ACCESSION NBR: 8310170446 DOC. DATE: 83/09/29 NOTARIZED: NO DOCKET #
 FACIL: 50-397 WPPSS Nuclear Project, Unit 2, Washington Public Powe 05000397
 AUTH. NAME: SORENSEN, G.C. AUTHOR AFFILIATION: Washington Public Power Supply System
 RECIP. NAME: SCHWENCER, A. RECIPIENT AFFILIATION: Licensing Branch 2

SUBJECT: Discusses history & background of use of fire dampers not fire rated or tested in const of facility, due to state of art const at time of installation, FSAR will be revised via Amend 33 to document const, Marked-up drawings encl.

Subject: NUCLEAR PROJECT NO. 2
FIRE DAMPER QUALIFICATION

RUSKIN MFG. CO.			
P.O. BOX 141		GRANDVIEW, MO. 64030	
REVISION #1 TWC			
TITLE FIRE DAMPER GUILLOTINE FDG TYPE			
DATE 12-4-75	BY 12-4-75	CHKD	2444

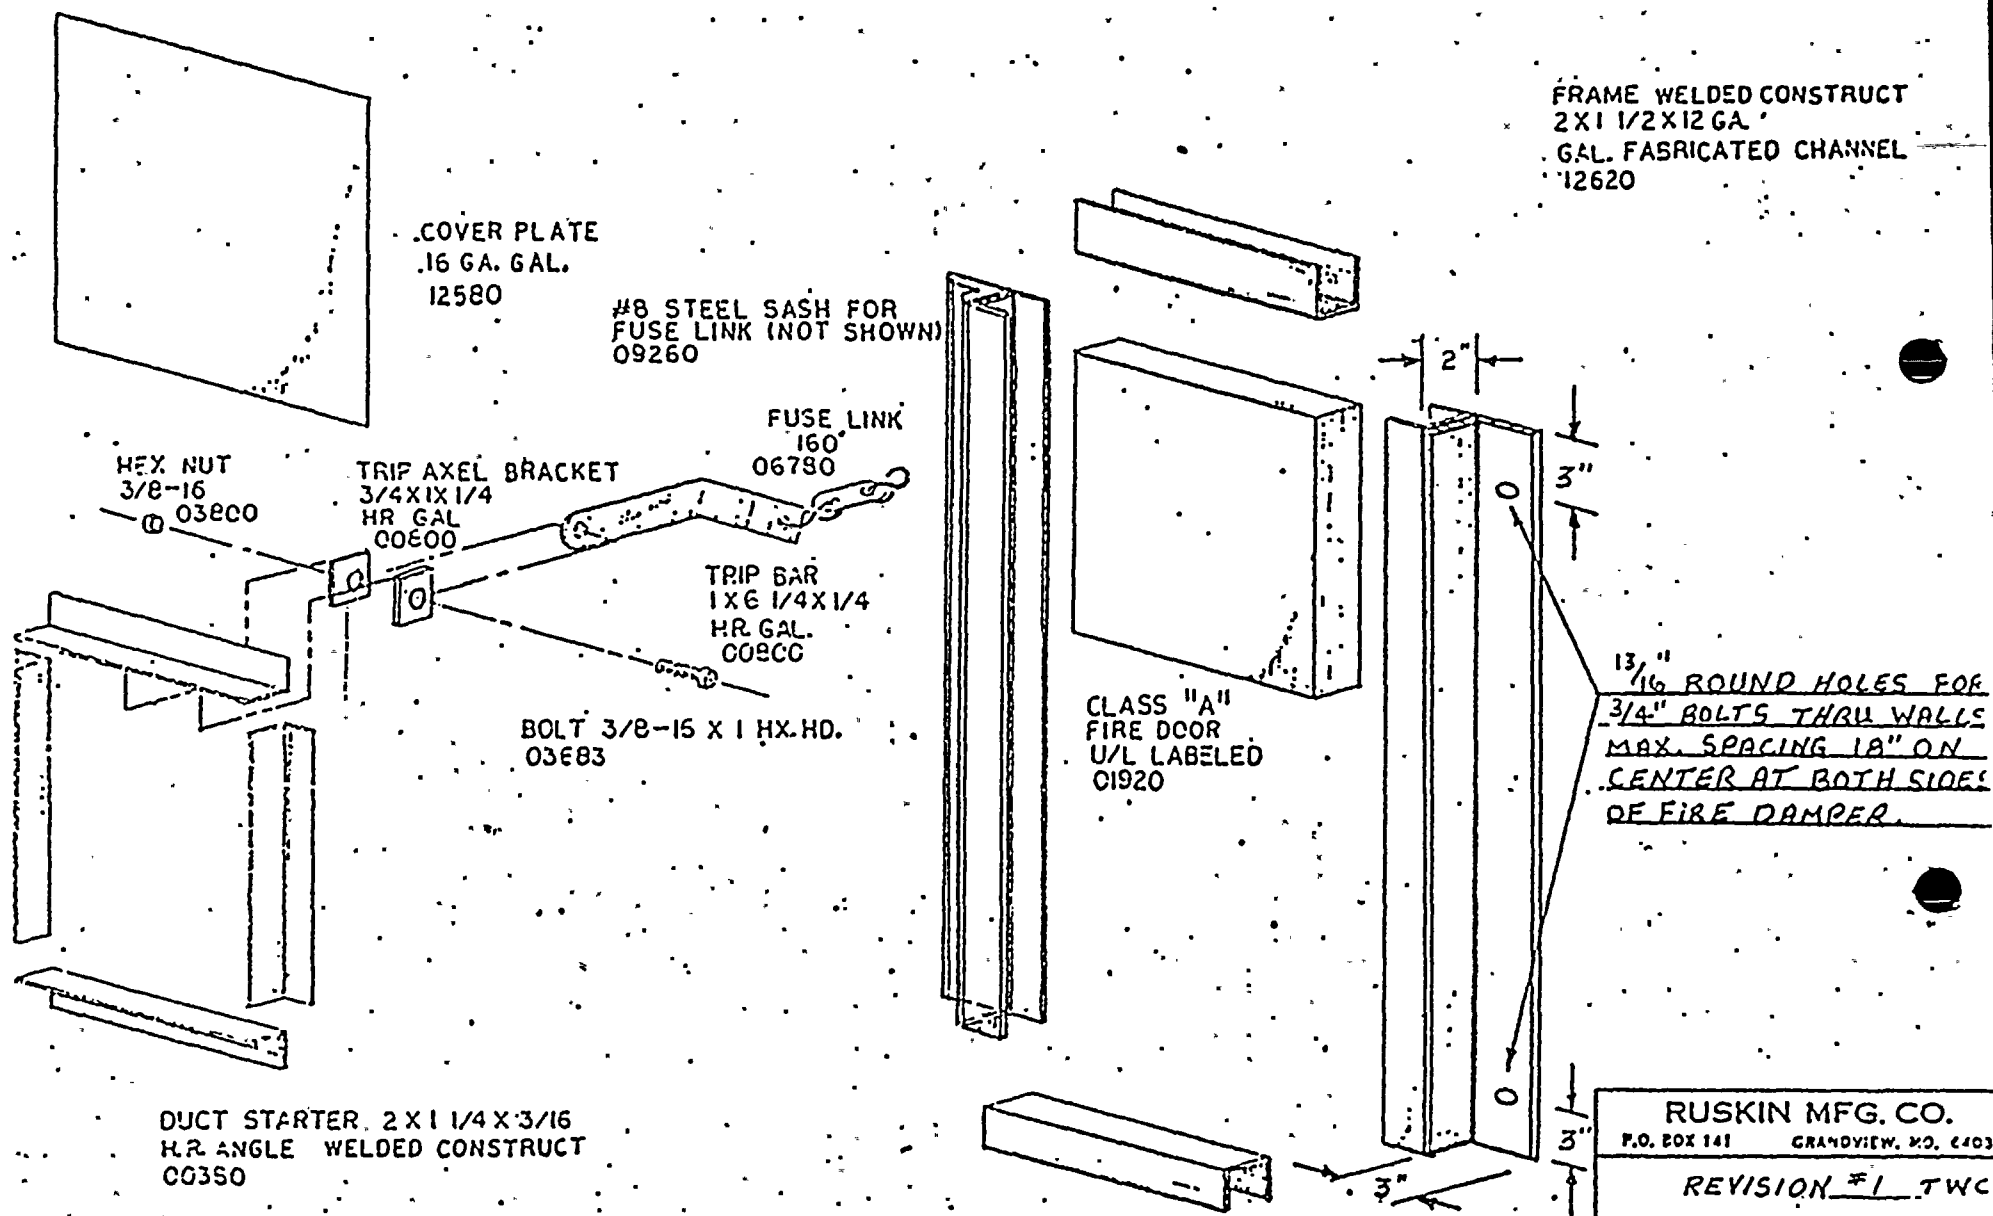
The construction of these fire dampers is shown in Attachment 2. The construction of the guillotine fire dampers includes a 3-hour UL labeled fire door in a 12 gauge "C" channel which is used as a guide for the door to slide in. A 3/16" angle is welded to the channel and the angle is bolted to the wall. The metal used in the "C" channel and angle are similar to the metal used in sliding fire door hardware and the attachment angle has the same thickness as fire door attachments.

TYPE: FDTD VERTICAL MOUNT

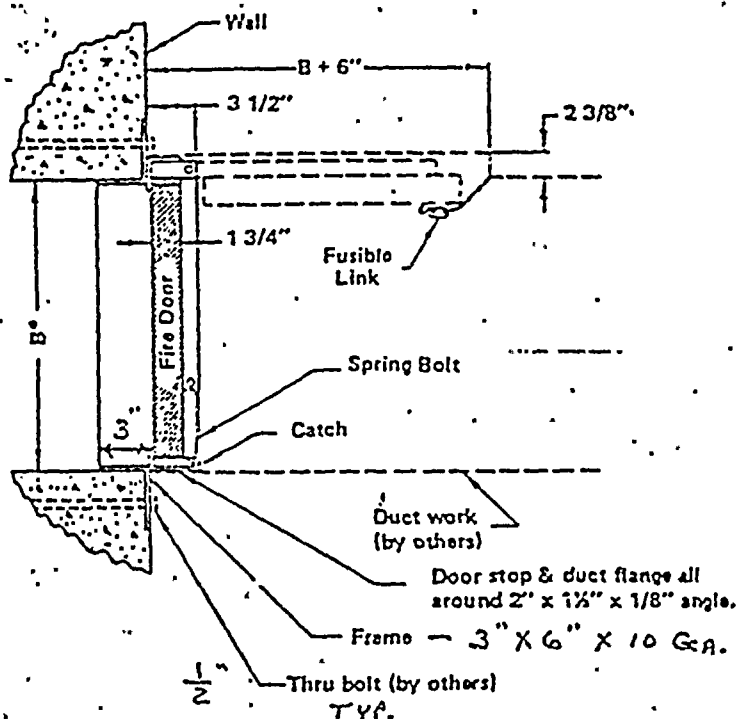
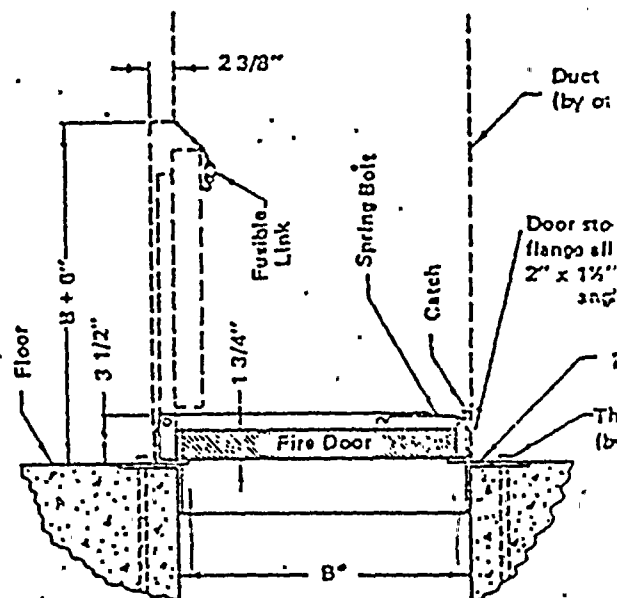
The trap door dampers are constructed using a 3-hour UL labeled fire door in a 10 gauge steel frame. These are installed both in the horizontal and vertical position and are bolted to the wall or floor using 1/2" diameter bolts or expansion bolts.

BURNS AND ROE, INC.	
ENGINEERS AND ARCHITECTS	
WASHINGTON PUBLIC POWER SUPPLY SYSTEM	
PROJECT NO. 1	
SHEET NO. 100-1	
DATE: 10/1/66	
BY: W.C. 2300	
CHECKED: 10/1/66	
APPROVED: 10/1/66

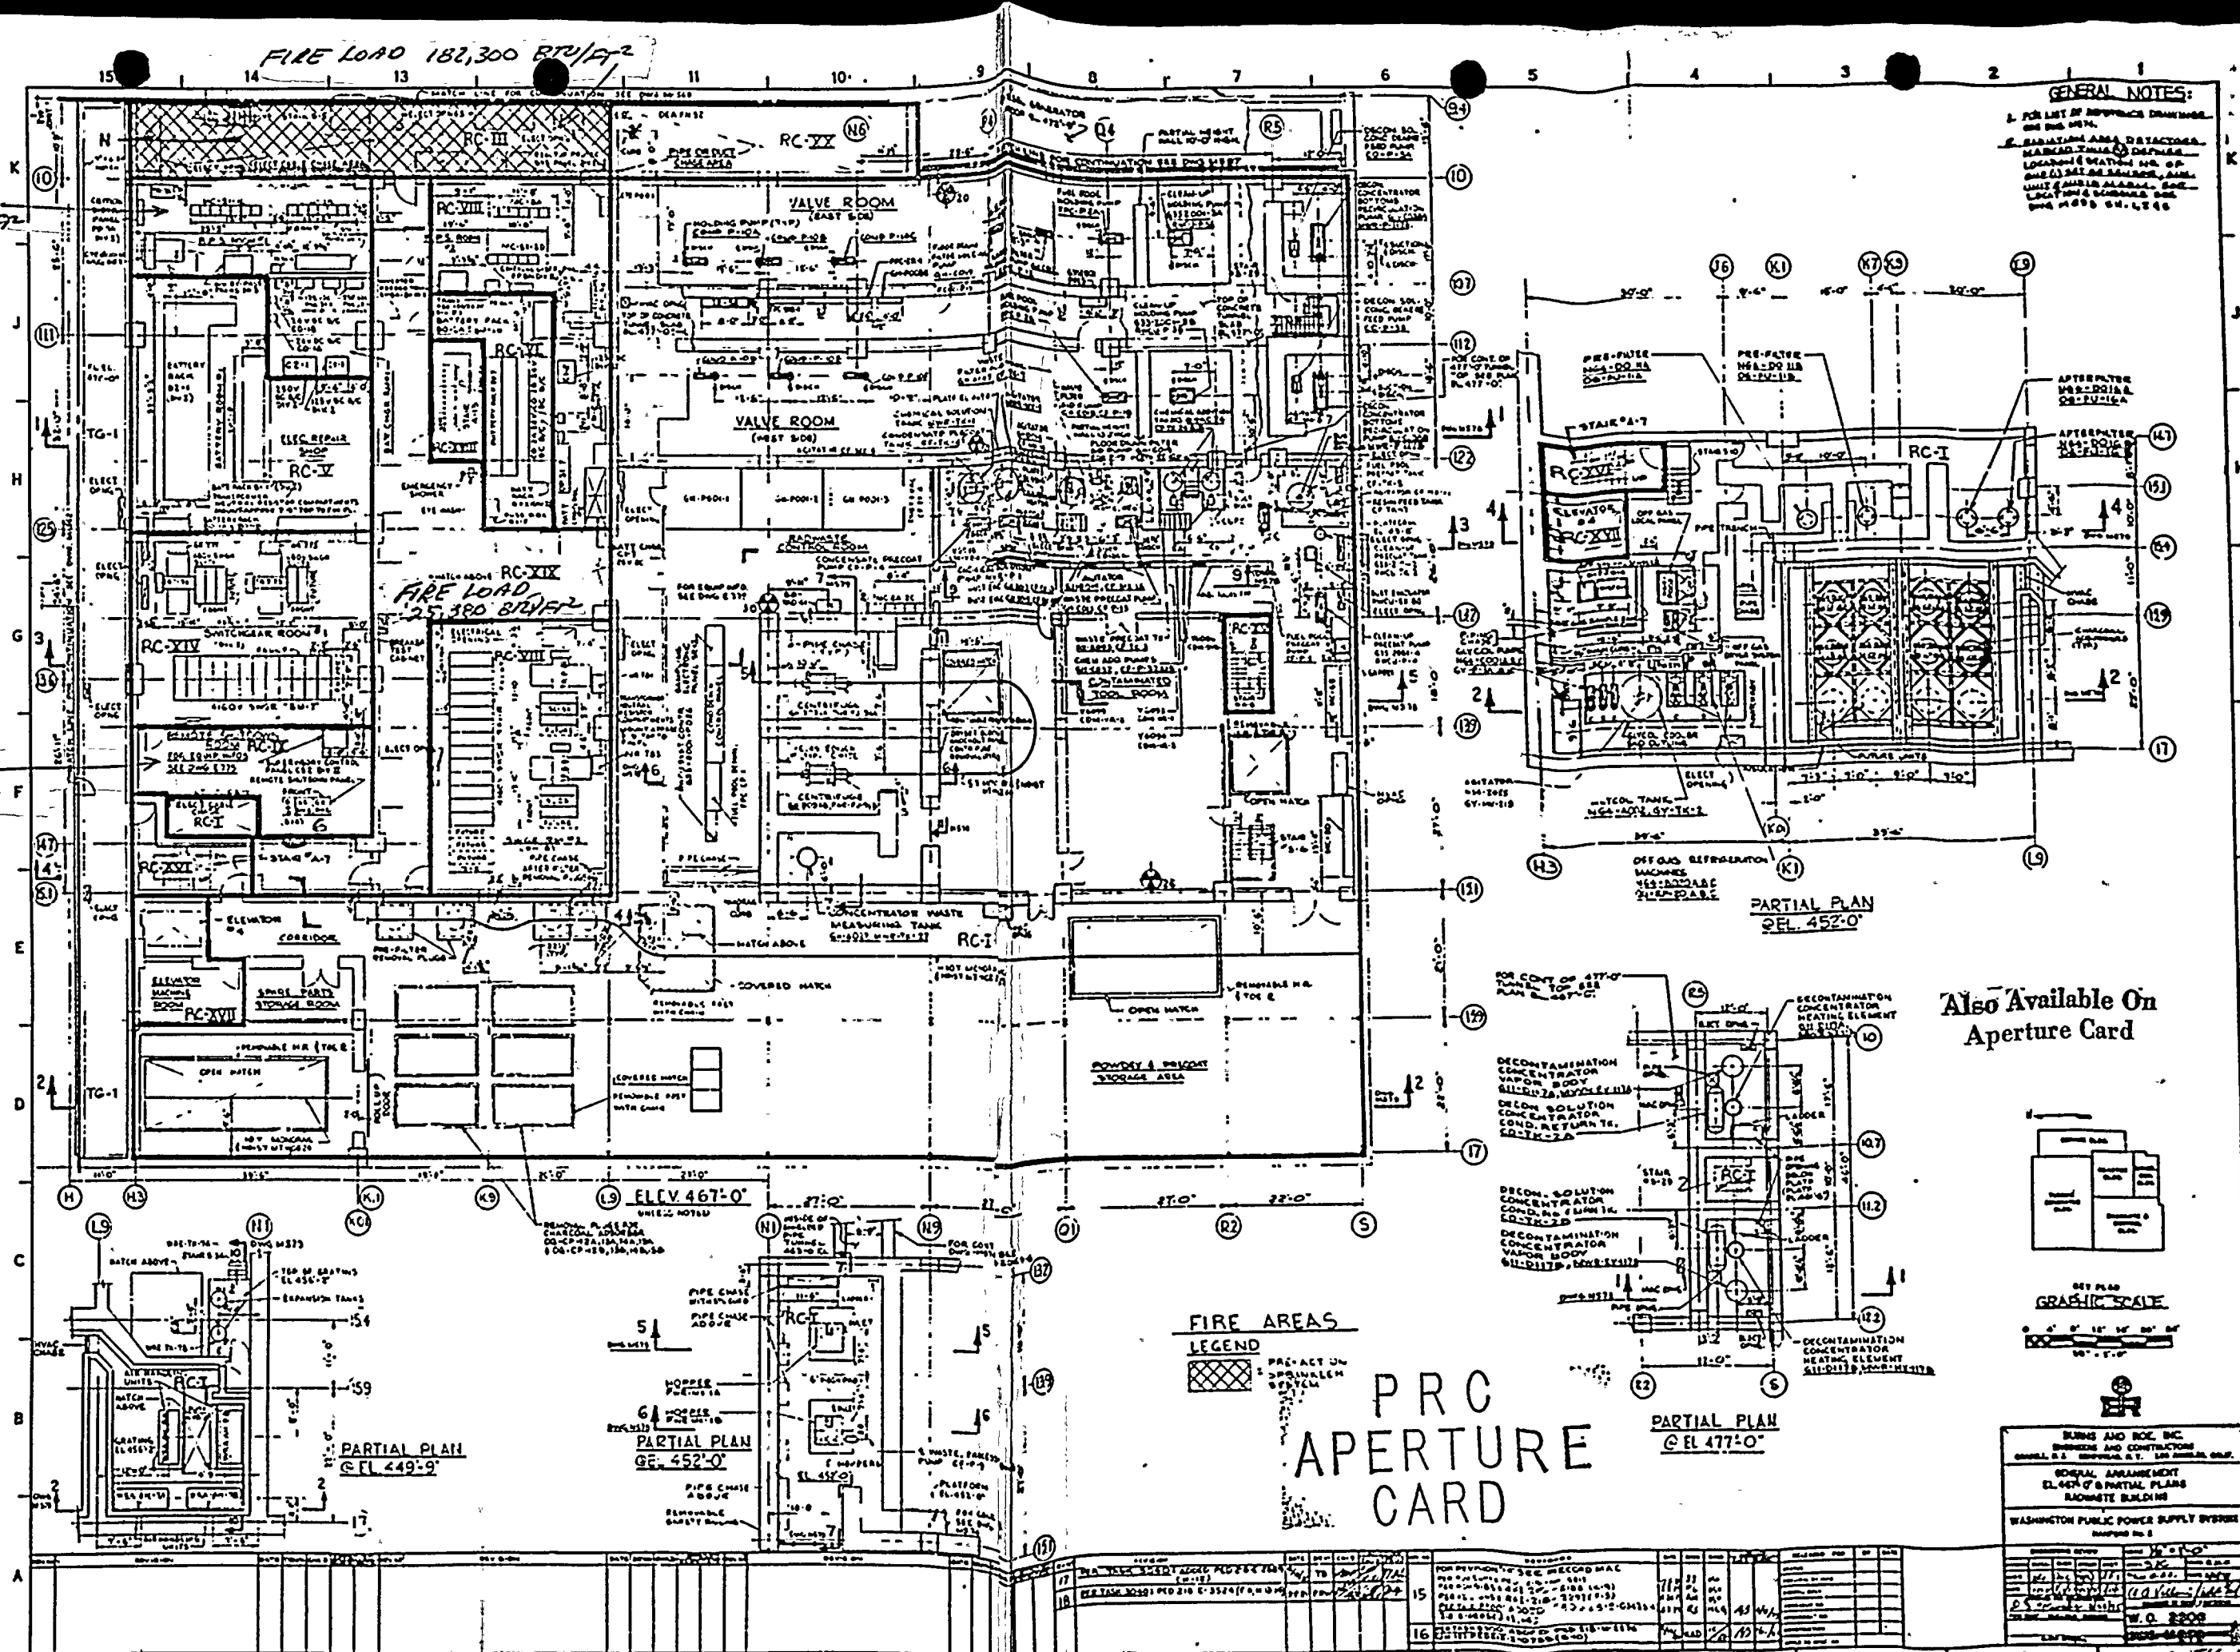
Attachment 3 shows the location and size of the dampers and the fire loading in each area involved. The location of the dampers are noted in red. The guillotine dampers are attached using through bolting on hollow block walls and expansion bolts on concrete walls.

6 G 15X15
20 G 60X20
21 G 60X20
22 TD 12X10
23 TD 12X10

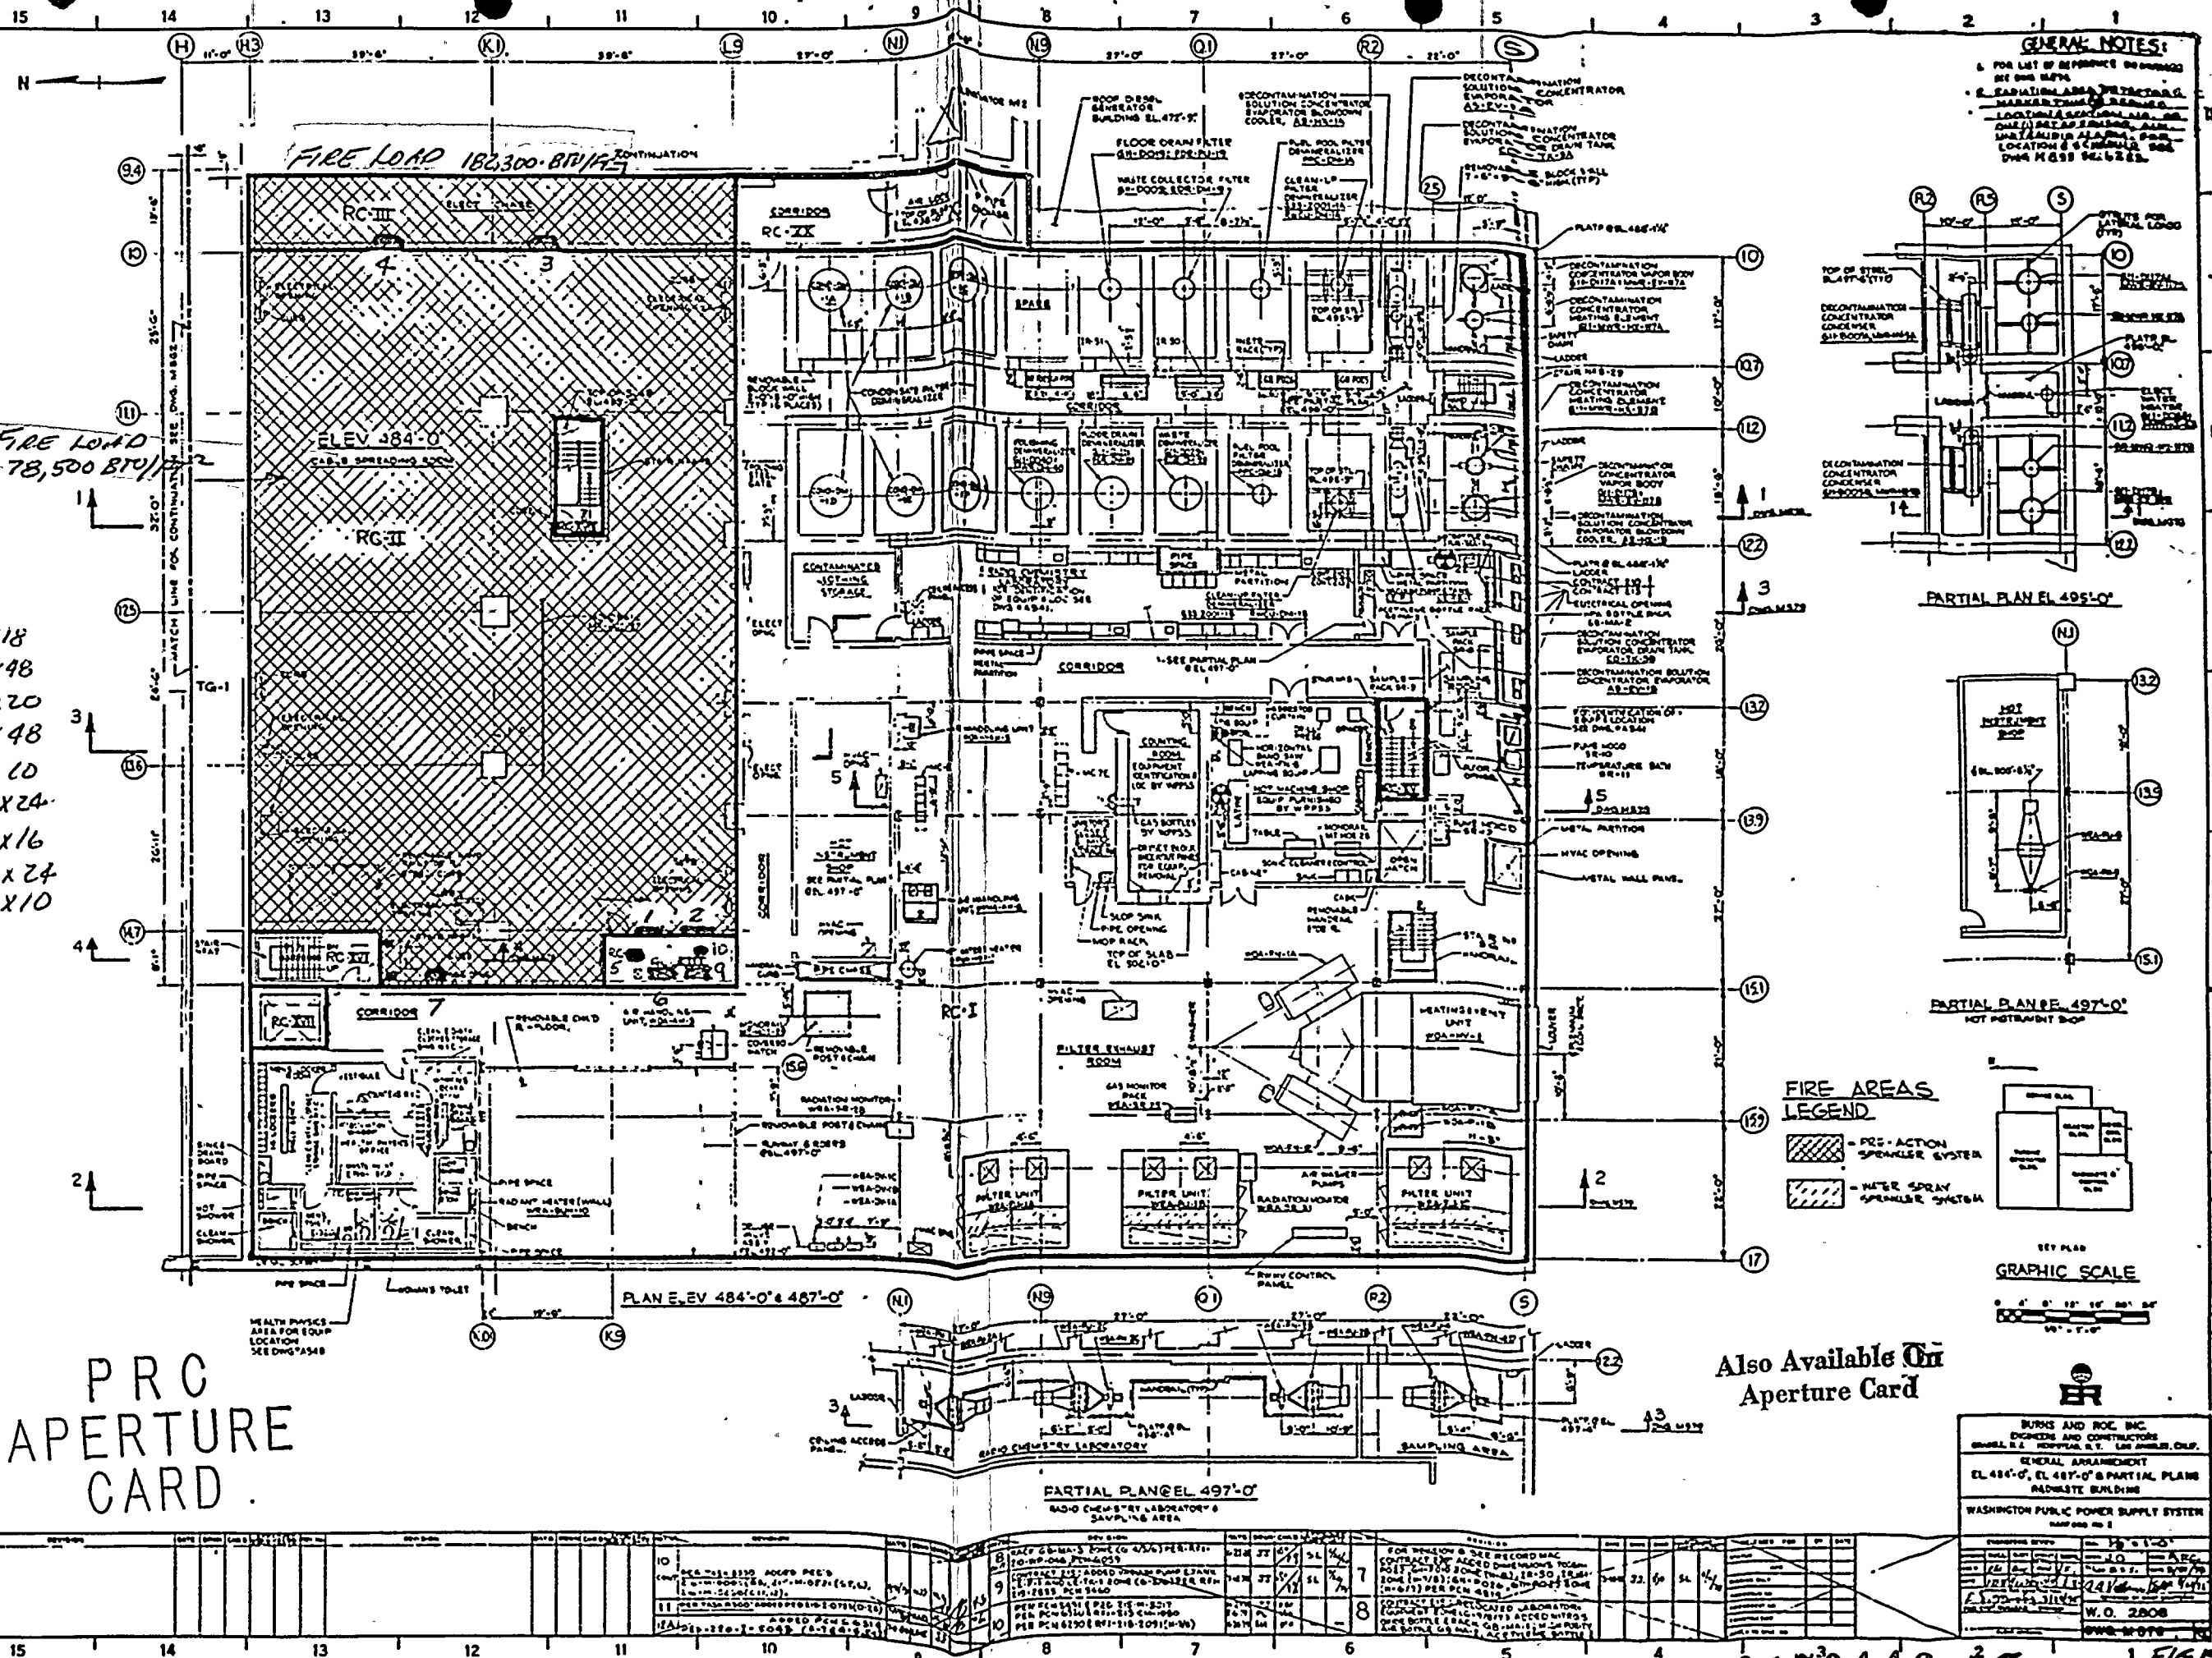
- 1 9 30x18
2 9 48x48
3 9 32x20
4 9 48x48
5 TD 12x10
6 TD 54x24
7 TD 16x16
9 TD 52x24
10 TD 12x10
